SERVICE INFORMATION LETTER

SERVICE INFORMATION LETTER NO. T-027

Revision 4

1. SUBJECT: Tail Rotor P/C Link Installation Inspection
2. MODEL: 480 and 480B
3. EFFECTIVITY: All
4. BACKGROUND:

**Figure 1. Tail Rotor Rotating Controls**

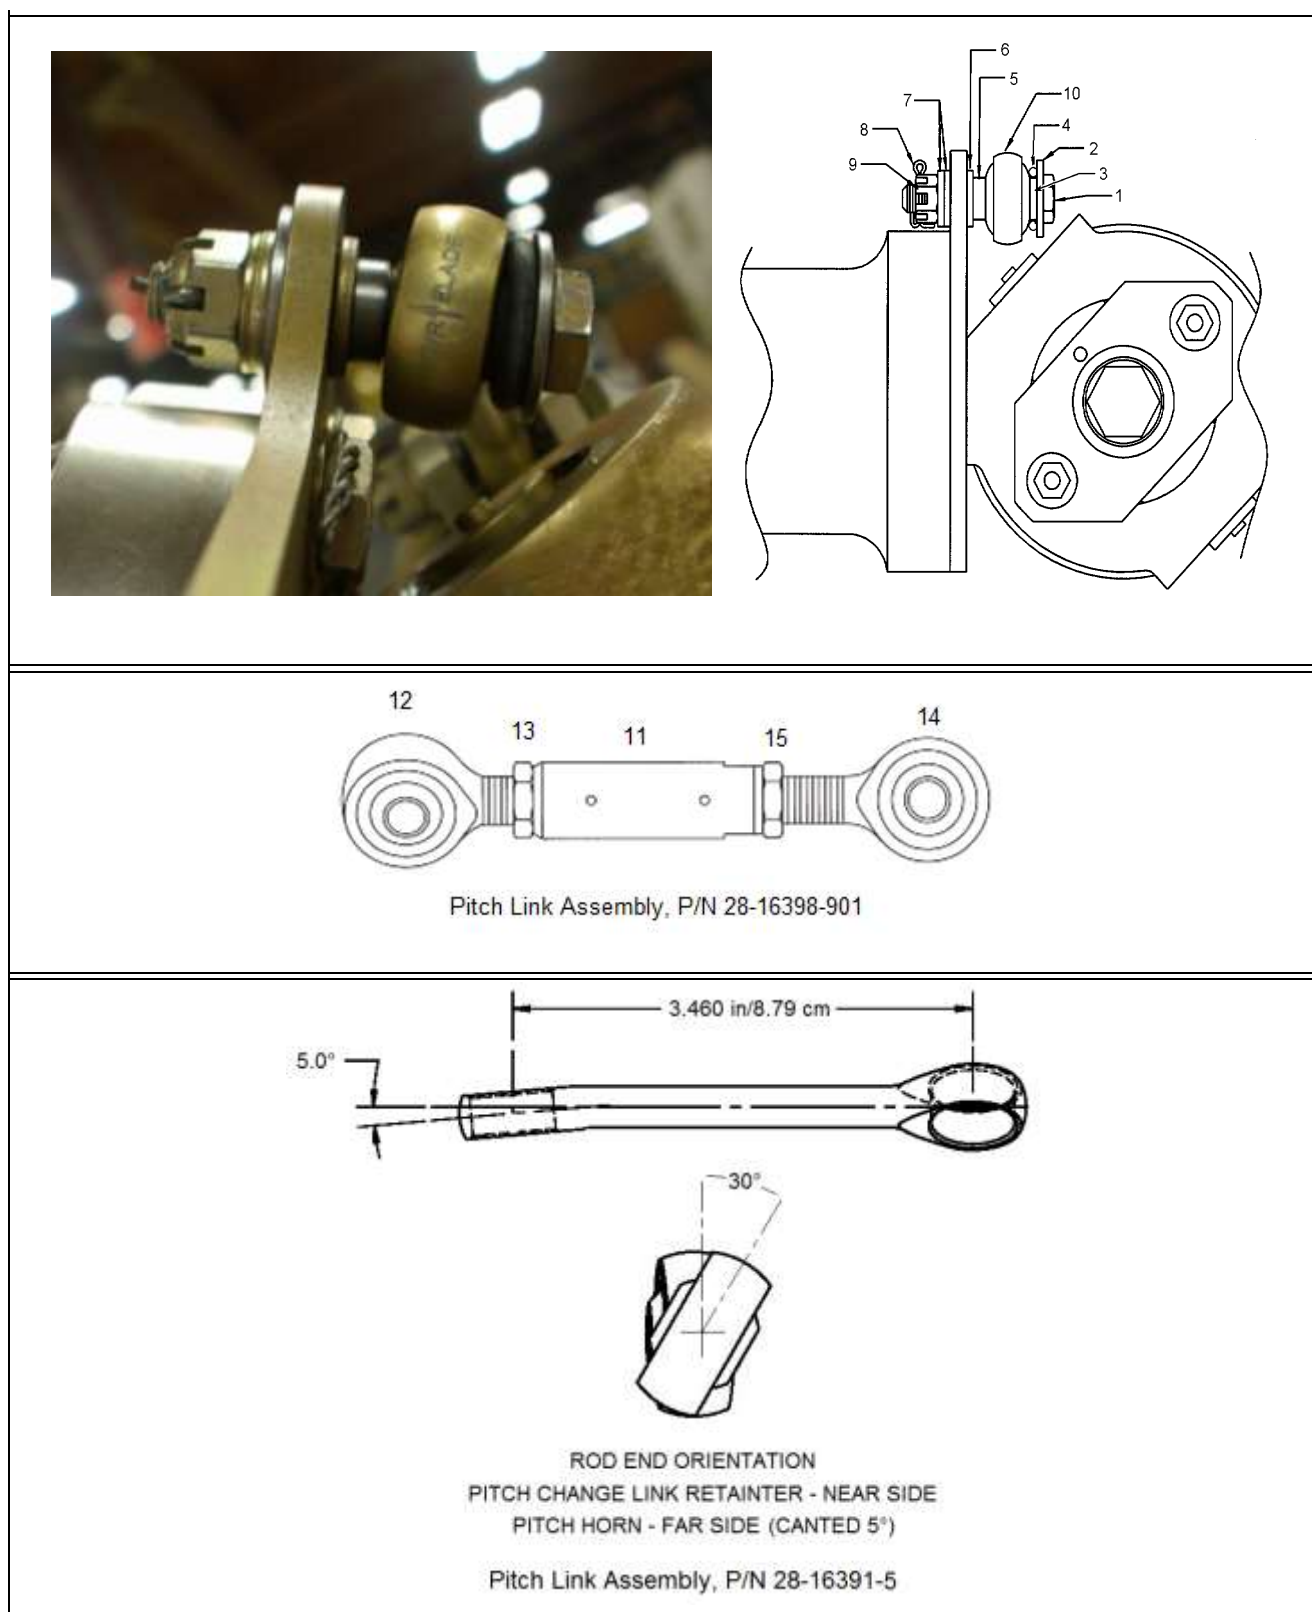
Revision 4 replaces AN960-416 washers (cad plated carbon steel) with NAS1149C0463R washers (passivated stainless steel). (Revision 4 supersedes SIL T-027 Revision 3.)
--

Revision 4 incorporates information on required washer replacement.

5.1.1 Inspect both tail rotor pitch link change installations for proper and secure installation hardware in accordance with Figure 1.

- 5.1.8 Connect the pitch change link (10) to the pitch arm with the hardware in the following sequence: bolt (1) (bolt head installed in the direction of rotation), Harper washer (2), thin spacer (3), O-ring (4), pitch change link rod end (10), thick spacer (5), washer (6), pitch arm, washer(s) (7), and nut (9). Torque the nuts (55-75 in-lbs/6.2-8.5 Nm) and install new cotter pin (8).

5.2.1 Remove and install the tail rotor pitch change link assemblies in accordance with the applicable maintenance instructions for each model aircraft and in accordance with step 5.1.8 above. **NOTE:** The P/N 28-16391-5 (and P/N 28-16391-3) tail rotor pitch link assembly has the label “T/R↑BLADE” etched on the rod end that is canted 5°. This end must attach to the tail rotor and the arrow must point toward the tail rotor blade (see photo in Figure 1).

* Use as required for dynamically balancing the tail rotor. Each AN960 washer is to be replaced with its equivalent size NAS1149C04XXR washer.

** Install each pitch change link assembly with the rod end labeled T/R↑BLADE on the tail rotor pitch horn side with arrow pointing toward the tail rotor blade.
